Skiptop & Skiptop 2.0 Powerpacks

Replacing Skiptop powerpack MU113481101 or Skiptop 2.0 powerpack MU113481102 with New generation Skiptop powerpack MU114088001

Replacement instructions

3. Bolt Power pack & cover plate fastening brackets - Fasten rubber silencer plate in the lower bracket with rivets, bolt upper bracket.

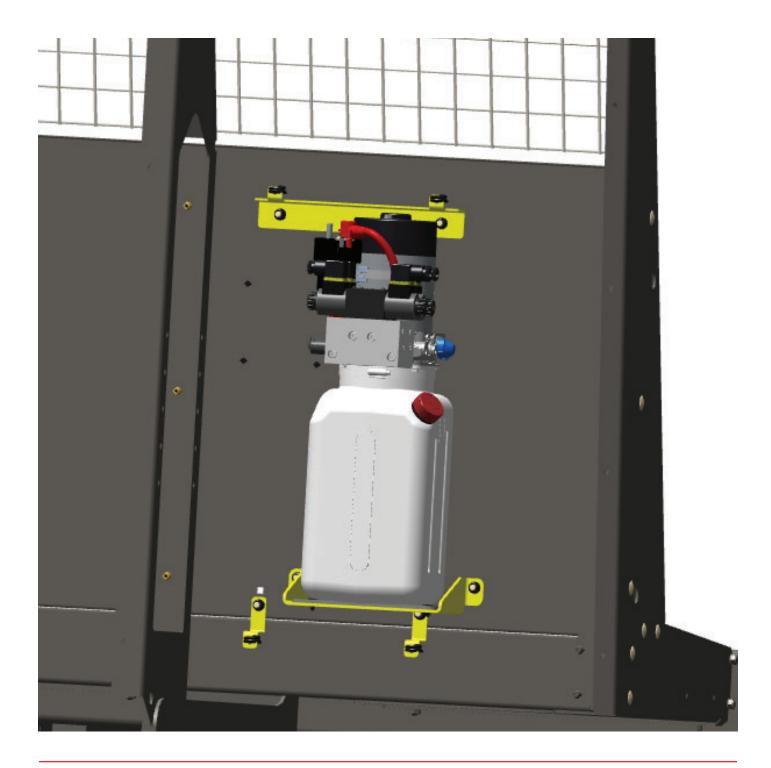
- Fasten power pack.
- Fit lower bracket and bottom supports.
- Brackets are highlighted yellow in the following figure.

5. Hydraulic connections

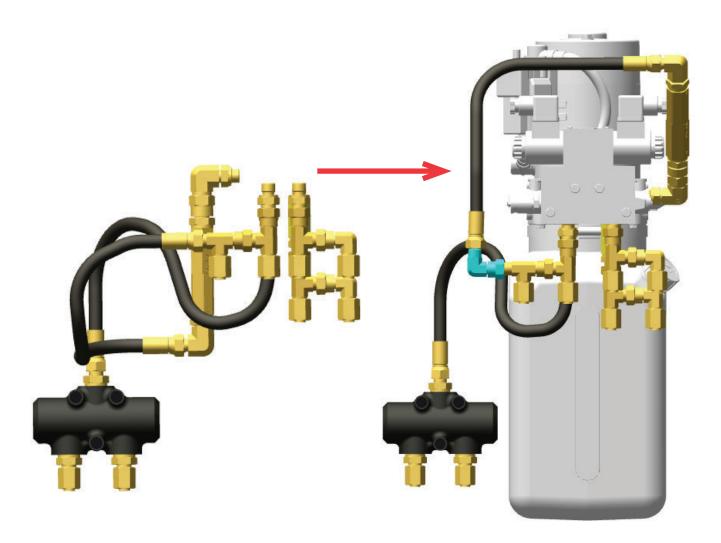
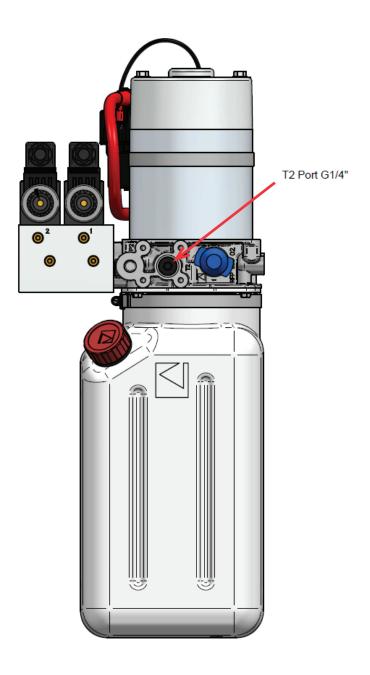
- Fasten released hoses in the power pack
- When replacing Skiptop 2.0 power pack MU113481102 one swivel nut MU110035806 for return line hose (highlighted in blue) needs to be added because the T-port is located on the other side of the pump unit. (See instructions in the following page)
- Skiptop 1 power pack MU113481101 is not equipped with this tank line so therefore the hose is not necessary.

6. Electric Schema

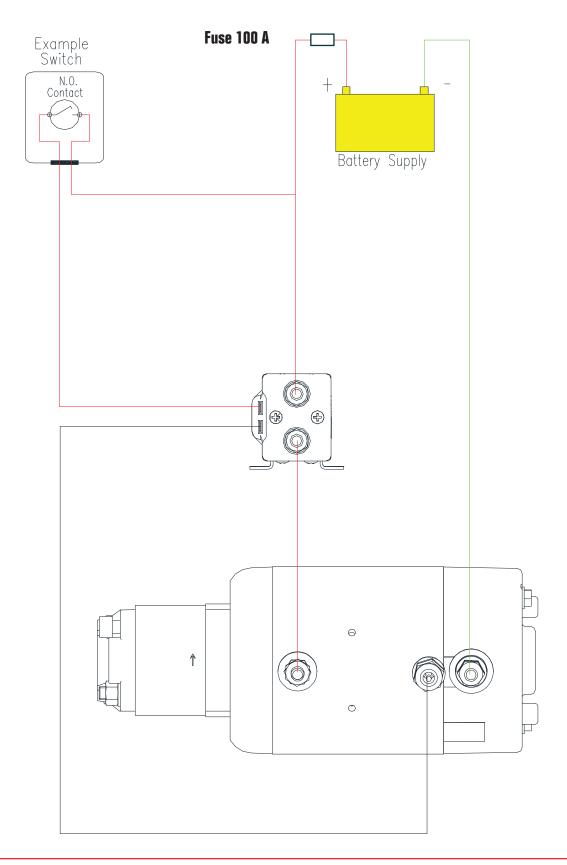
- Make sure to have a fuse 100 A max. 100 mm after battery + pole.

7. Electrical connections

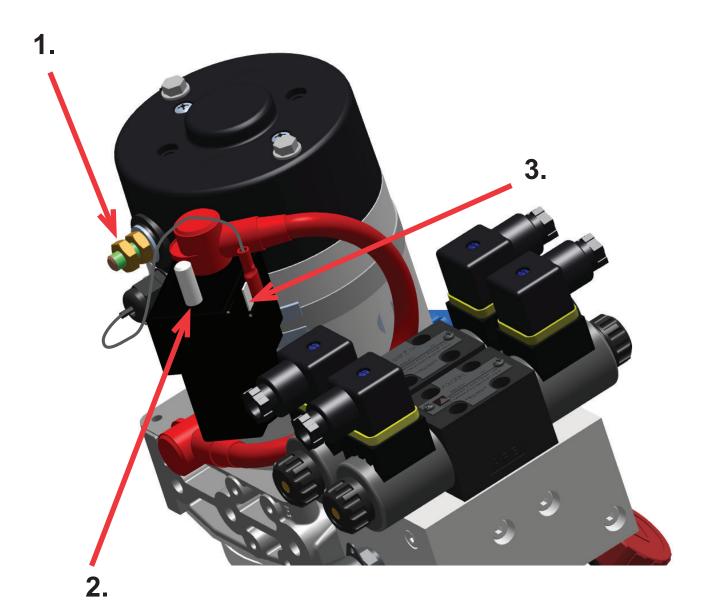
- 1. M8 earth terminal
- 2. +24 VDC from battery3. Start signal for pump (XM2.08 DO, Control module 3724)

7. Pressure adjustment (Only when replacing MU113481101)

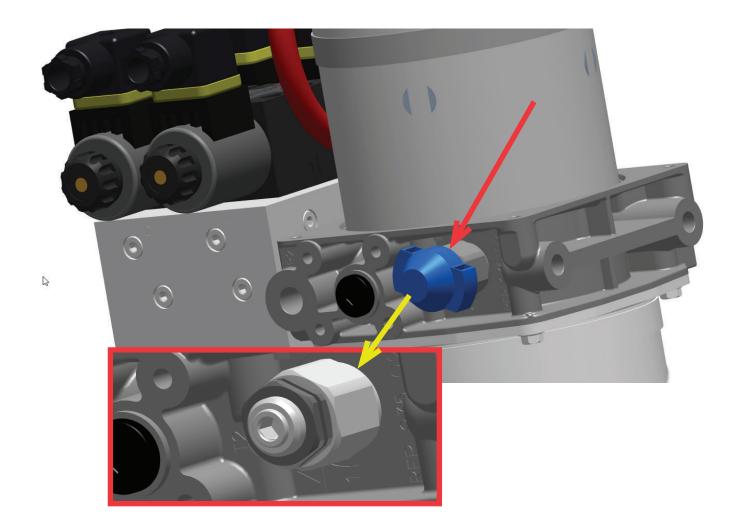
- Due to different structure of the hydraulic system of Skiptop 1 the pressure must be lowered to 150 bar from the standard adjustment 180 bar.
- Open blue tamper resistant cap.

- Operate the cylinder against one end, measure pressure from the power pack pressure measurement nipple.
- Adjust and fasten the adjustment and re-seal with a new tamper resistant cap.
- Install plastic cover
